The Commission has issued the enclosed Amendment No. 15, Technical Specification Change No. 25 for License No. DPR-38; Amendment No. 15, Technical Specification Change No. 20 for License No. DPR-47; and Amendment No. 12, Technical Specification Change No. 12 for License No. DPR-55, for the Oconee Nuclear Station, Units 1, 2, and 3. These amendments are in response to your request dated November 10, 1975.

These amendments provide Oconee Unit 1 control rod position and operational power imbalance limits for four-pump operation applicable to the period after 245 + 10 Effective Full Power Days of operation.

AMENDMENT NO. 15 TO FACILITY LICENSE NO. DPR-38
CHANGE NO. 25 TO TECHNICAL SPECIFICATIONS;

Revise Appendix A as follows:

Figure 3.5.2-1A2

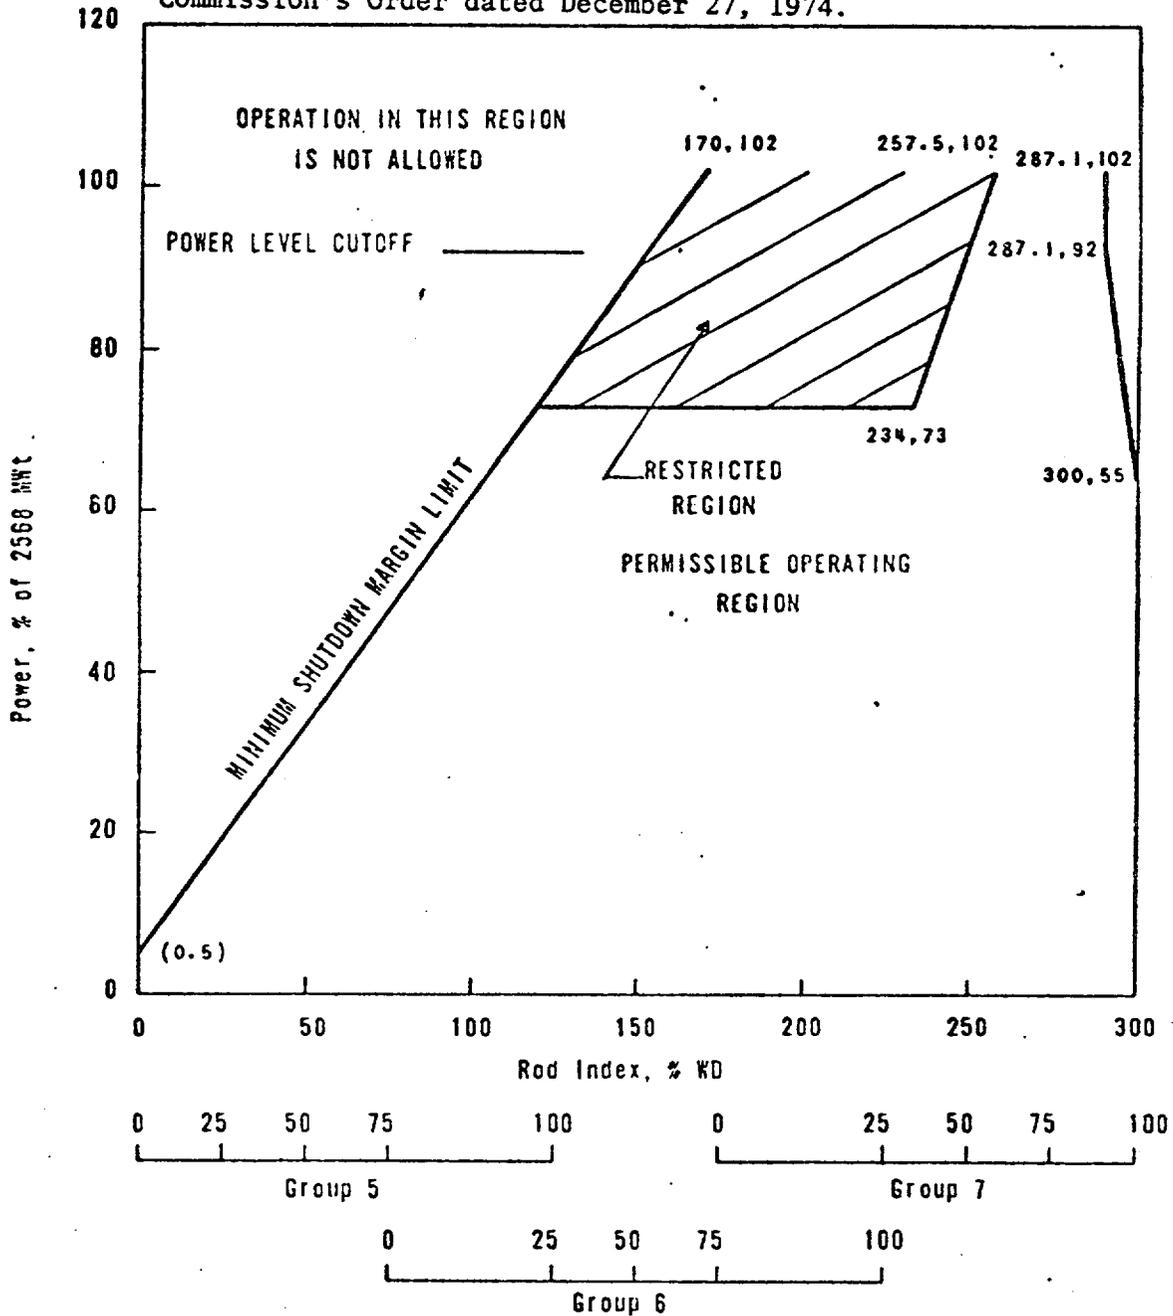
ROD POSITION LIMITS FOR 4 PUMP OPERATION APPLICABLE TO THE PERIOD AFTER 245 ± 10 EFPD, as provided for in the Commission's Order dated December 27, 1974.

Rod index is the percentage sum of the withdrawal of Groups 5, 6 and 7.

UNIT 1
ROD POSITION LIMITS FOR
4 PUMP OPERATION

By letter dated November 10, 1975, Duke Power Company (the licensee) requested a change in the Technical Specifications of Licenses No. DPR-38, DPR-47, and DPR-55 for the Oconee Nuclear Station, Units 1, 2, and 3. The proposed amendments would provide Oconee Unit 1 control rod position (withdrawal) and operational power imbalance limits for four pump operation applicable to the period after 245 ± 10 Effective Full Power Days (EFPD) of operation.

The proposed rod withdrawal and axial power imbalance limits for operation beyond 245 ± 10 EFPD were calculated by the licensee using methods we have previously found acceptable and upon which we relied in establishing the necessary operating restrictions in the Order. We, therefore, conclude that operation of Unit 1 beyond 245 ± 10 EFPD with the proposed rod withdrawal and axial power imbalance limits, and with no change in the other operating restrictions in the Order, will assure that ECCS cooling performance will continue to conform to all of the criteria contained in 10 CFR §50.46(b), which govern calculated peak clad temperature, maximum cladding oxidation, maximum hydrogen generation, coolable geometry and long-term cooling.

Figure 3.5.2-3A

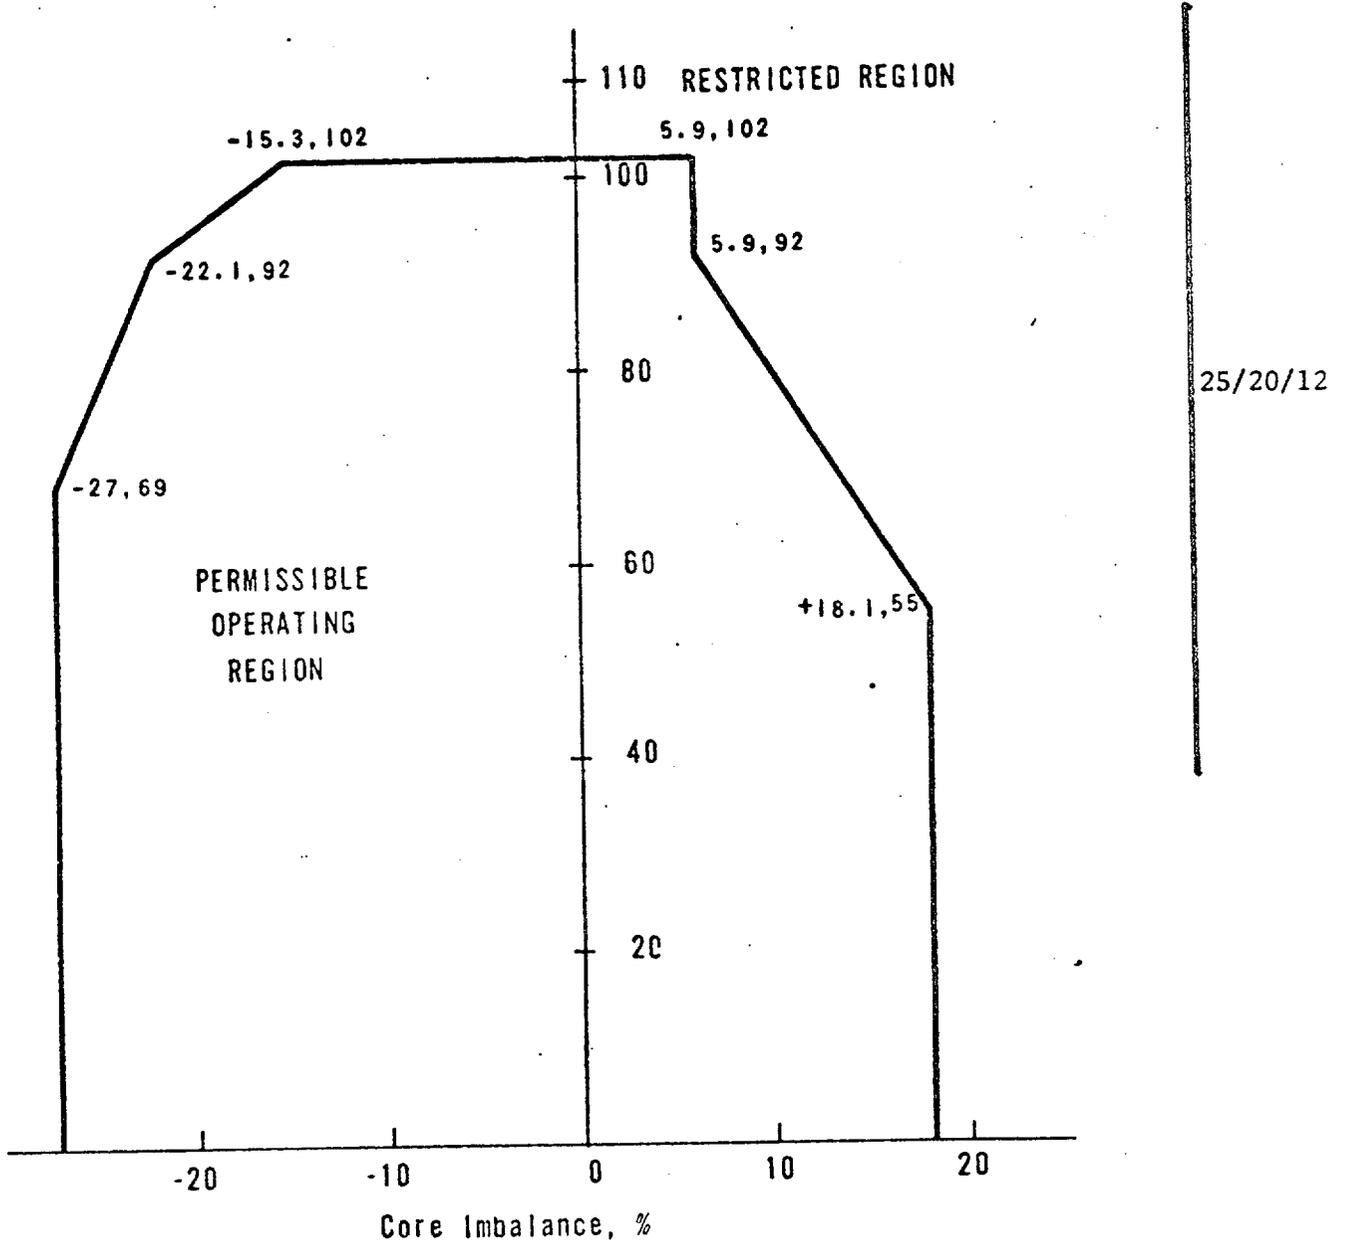
UNIT 1
OPERATIONAL POWER IMBALANCE ENVELOPE

(for operation beyond 250 EFPD) was recognized and provided for in the Order and, with respect to the axial power imbalance limits, the new limits are more restrictive than those in the Order.

In summary, we have concluded that the proposed rod withdrawal and power imbalance limits for Oconee Unit 1 meet the requirements of the Order of December 27, 1974, and provide reasonable assurance that the public health and safety would not be endangered. We, therefore, find the proposed amendment to be acceptable.
